NUCLEAR ENGINEERING AUDIT

QAS-JPN-95-1

QUALITY ASSURANCE AUDIT REPORT
QAS-JPN-95-1

Subject: FUNCTIONAL AREA AUDIT OF NUCLEAR ENGINEERING QAS-JPN-95-1

* JPN-123-191.011 REV.0

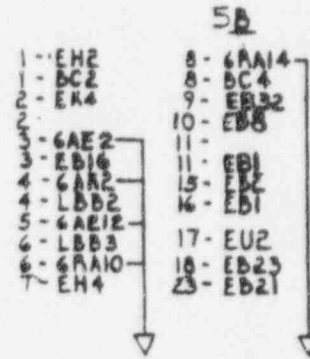
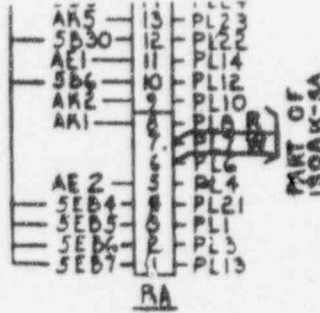
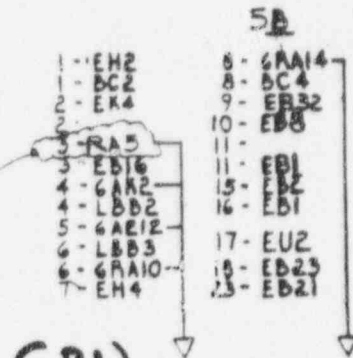
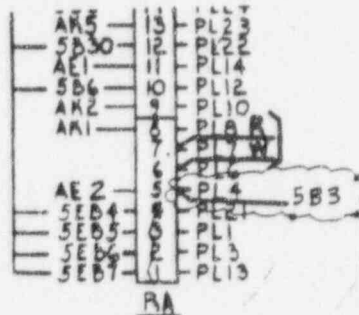
CHANGE REQUEST NOTICE																		
PC/M No. <u>123-191M</u>		GWO No.																
PLANT <u>PSC</u> UNIT <u>1</u>		HPWO No. <u>5878</u>																
Rel. Dwg. or Spcc. <u>*</u>		Rev.																
Reason for Change: <u>PC/M 123-191 REQUIRES THAT THE RELAY AS-FOUND CONDITION BE VERIFIED TO THE VENDOR DRAWING REFERENCED BY THE PC/M DRAWING. THE RELAY AS-FOUND CONDITION DOES NOT AGREE WITH THE VENDOR DRAWING BUT HAS BEEN VERIFIED TO BE ELECTRICALLY CORRECT.</u>		TITLE <u>DC LOAD SEQUENCING RELAYS</u>																
Change Request/Revision (Attach if necessary): <u>MAKE THE CHANGES TO THE DRAWINGS REFERENCED ABOVE AS SHOWN ON THE FOLLOWING PAGE(S).</u>																		
SOURCE OF CHANGE:		SCOPE OF WORK:																
<input type="checkbox"/> Construction Error <input type="checkbox"/> Engineering Error <input checked="" type="checkbox"/> Existing Condition <input type="checkbox"/> Material Substitution <input type="checkbox"/> Constr. Convenience <input type="checkbox"/> Design Evolution <input type="checkbox"/> Other (specify)		<input type="checkbox"/> Increased <input type="checkbox"/> Decreased <input checked="" type="checkbox"/> Unchanged																
APPROVALS:		Implemented by: <u>LUKE CLARK</u> Date <u>4/3/93</u> Dept. <u>EIM</u> Phone <u>5251</u> Impl. Dept. Supv. <u>John Clark</u> Date <u>4/3/93</u> QC Review: <u>[Signature]</u> Date <u>4/5/93</u> FPL Const. Supv. <u>NA</u> Date <u>1/1</u>																
ACTION BY ENGINEERING (Preliminary):		In Person <input checked="" type="checkbox"/> Process <input checked="" type="checkbox"/> Telephone <input type="checkbox"/> Hold <input type="checkbox"/>																
This CRN has been discussed with <u>BRIAN GRINER</u> of Engineering.																		
ENGINEERING DISPOSITION (Final):		IMPACT OF REVISION CHECK SHEET																
<input checked="" type="checkbox"/> APPROVED <input type="checkbox"/> NOT APPROVED <u>JPN</u> Cognizant Design Org. (CDO) Prepared by <u>Tom [Signature]</u> Date <u>4/12/93</u> Verified by <u>[Signature]</u> Date <u>4/12/93</u> Approved by <u>C. J. [Signature]</u> Date <u>4/13/93</u> JPN (if not CDO) _____ Date _____
